## Director-General's Report

### Application to Modify the Minister's Approval for a Residential Subdivision at 1 Survey Street, Lennox Head (Lot 2 DP622475)

#### Major Project 06\_0002 MOD 1

Figure 2: Councils Preferred Alignment

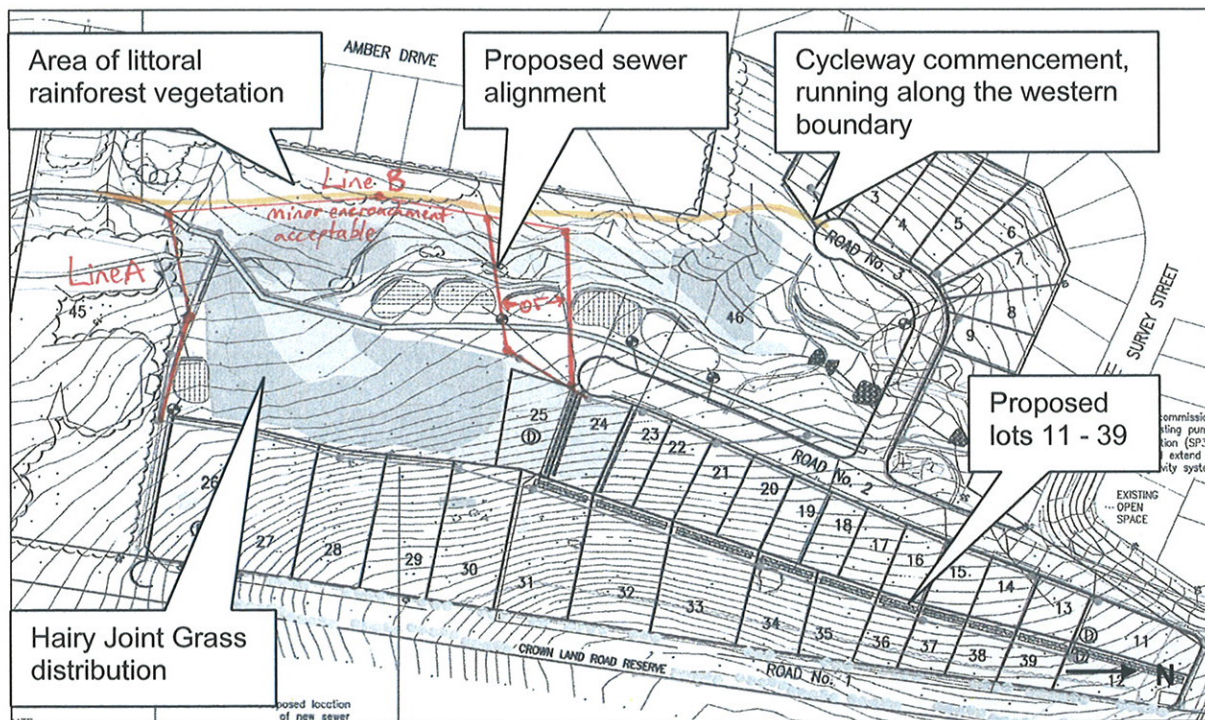
- The cycleway route along the western edge of the site is a more desirable outcome as minimal tree removal is required; it does not remove any areas of littoral rainforest; and, the trees required to be removed along the western edge of the site are already dying due to excessive groundwater and overcrowding;

- The cycleway is located in an area subject to constant groundwater seepage and it is unknown what sort of ecological impact an elevated boardwalk in this location will have on areas of HJG.
- The height of the elevated boardwalk needs to be determined to allow for the management of HJG underneath; and
- The cycleway alignment through the ecological polygon will attract people to the area, increasing the potential for detrimental ecological impacts and disturbances.

- An elevated boardwalk structure as proposed requires a greater level of ongoing maintenance than a standard concrete footpath/cycleway;
- A concrete path as opposed to a boardwalk has a greater lifespan (20 to 30 years); is less vulnerable to vandalism; and will provide less cost to Council over its serviceable lifespan; and
- A boardwalk will require handrails at either side, which creates an increased risk to cyclists should they accidentally veer off course. In addition, the metal surface of the elevated boardwalk would be a more slippery surface than a concrete path, particularly when wet.

An alternative cycleway and sewer alignment was provided by Council and is depicted in **Figure 2** below.

From an urban design perspective, the modified cycleway alignment is the preferred option as it is more easily accessible for a greater number of people than the alignment proposed by Council; and is less likely to facilitate anti-social behaviour. The cycleway alignment as conditioned under the existing approval and the option preferred by Council would see the cycleway beginning at the end of a cul-de-sac road (refer **Figure 2**), a greater distance from lots 11 to 39 than the proposed modified alignment. If the cycleway was constructed as proposed by Council, it would run alongside the rear boundaries of Amber Drive residential properties and adjacent to significant areas of dense vegetation cover. It is considered that this alignment has the potential to detrimentally impact on the social environment of the locality as it presents a greater opportunity for anti-social behaviour being in an area that is at the rear of existing properties and concealed by the existing dense vegetation matter.

The Department considers that the modified cycleway alignment is an acceptable route due to the fact that a significant area of littoral rainforest vegetation will be retained; measures to protect the HJG ecological polygon are implemented; and, sound urban design principles are adhered to.

**Figure 3: Proposed Cycleway Alignment**

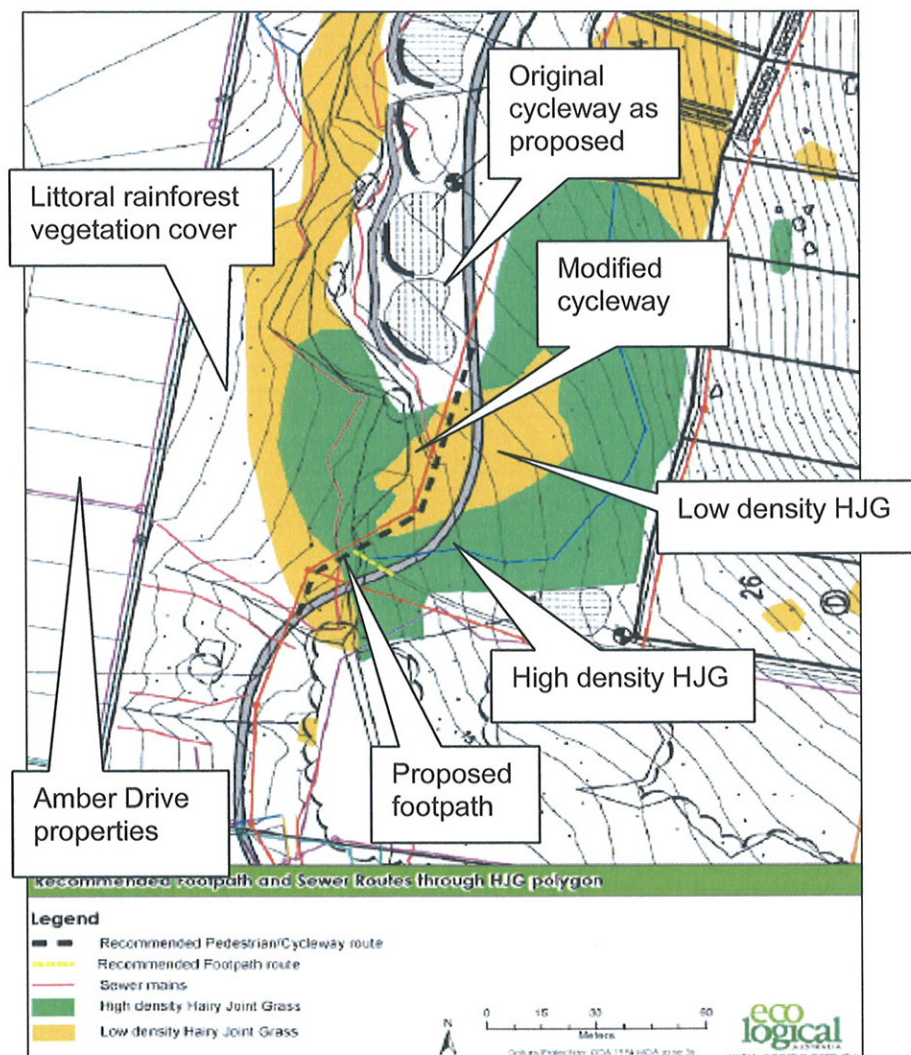
In order to minimise the impacts on the HJG distribution within the site, a recommended condition of approval for the original application required the north-south oriented cycleway connecting to Seamist Place to be relocated along the western site boundary and outside of the area populated by HJG. A study undertaken by Eco-Logical Australia has identified the areas of high density and low density HJG distribution, as illustrated in **Figure 3** below. **Figure 3** also indicates the area of littoral rainforest identified by DECC along the western site boundary. The modification application seeks to maintain the north-south cycleway generally in the same alignment as proposed, although moved marginally to the west through an area of low density HJG and crossing a narrow band of high density HJG. The proposed alignment is the shortest possible route through the HJG ecological polygon. This alignment will avoid the need to remove areas of dense littoral rainforest vegetation along the western boundary of the site and to the rear of existing Amber Drive properties.

The proponent has advised that a raised boardwalk platform will be constructed over the ecological polygon of HJG. The proposed boardwalk will be perforated, which will allow for natural sunlight to penetrate to the areas of HJG below. In addition, the boardwalk will have handrails on either side to prevent cyclists and pedestrians from entering within the HJG ecological polygon. The Department has recommended a condition of approval that the cycleway be constructed in accordance with DECC's *Guidelines for the Design and Construction of Paths Along Watercourses and Riparian Areas*. This will ensure the functioning of the existing watercourse is not adversely impact upon by the proposed cycleway.

Eco-Logical Australia recommended construction works within the HJG distribution area only be undertaken only during the winter months as during this time HJG seedlings have not yet emerged; and, as the winter months are traditionally the driest, heavy rainfall is less likely to create soil erosion and potentially deposit destructive weed seedlings into the HJG distribution area. The conditions of approval have been amended to ensure the cycleway is constructed during the winter months to minimise impacts on the existing HJG population.

- (c) The design is to include an elevated structure/boardwalk over the Hairy Joint Grass ecological polygon which is high enough to enable the management of Hairy Joint Grass by seasonal slashing;

- (d) The design is to consist of perforated or transparent material over the ecological polygon to allow for the penetration of natural light to areas of Hairy Joint Grass below; and

**Figure 4: Proposed Sewer Alignment**

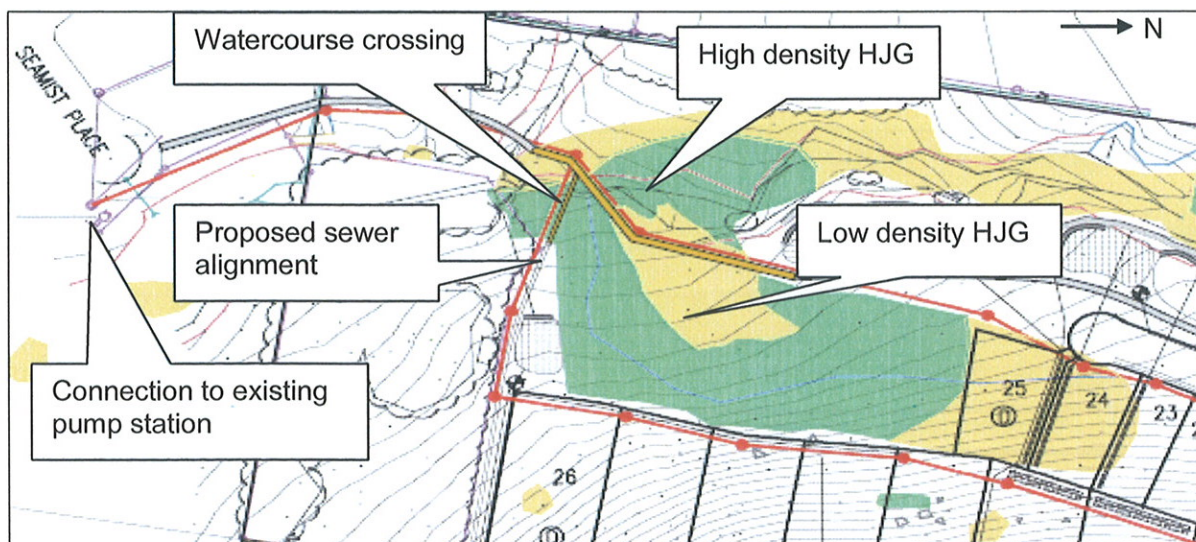
The proposed sewer alignment connects to the existing pump station at the end of Seamist Place, as illustrated in **Figure 4** below. The topography of the site slopes generally to the south which is an ideal arrangement considering the sewer network is a gravity fed system. From an engineering perspective, the modified sewer alignment is a preferred arrangement as the sewer trench (which is approximately 1m in width) is short, direct, and is gravity fed to the existing pump station. The proposed alignment is also favourable from an environmental perspective as the clearing of littoral rainforest vegetation along the western site boundary is avoided, and the sewer line only crosses the existing watercourse at a single location. DECC has advised that sewer alignment as proposed is the preferred arrangement for the site.

The Department considers the modified sewer alignment as a more favourable route as it is generally aligned in the same configuration as the proposed cycleway; avoids the removal of littoral rainforest vegetation; and crosses the existing watercourse at only a single location.
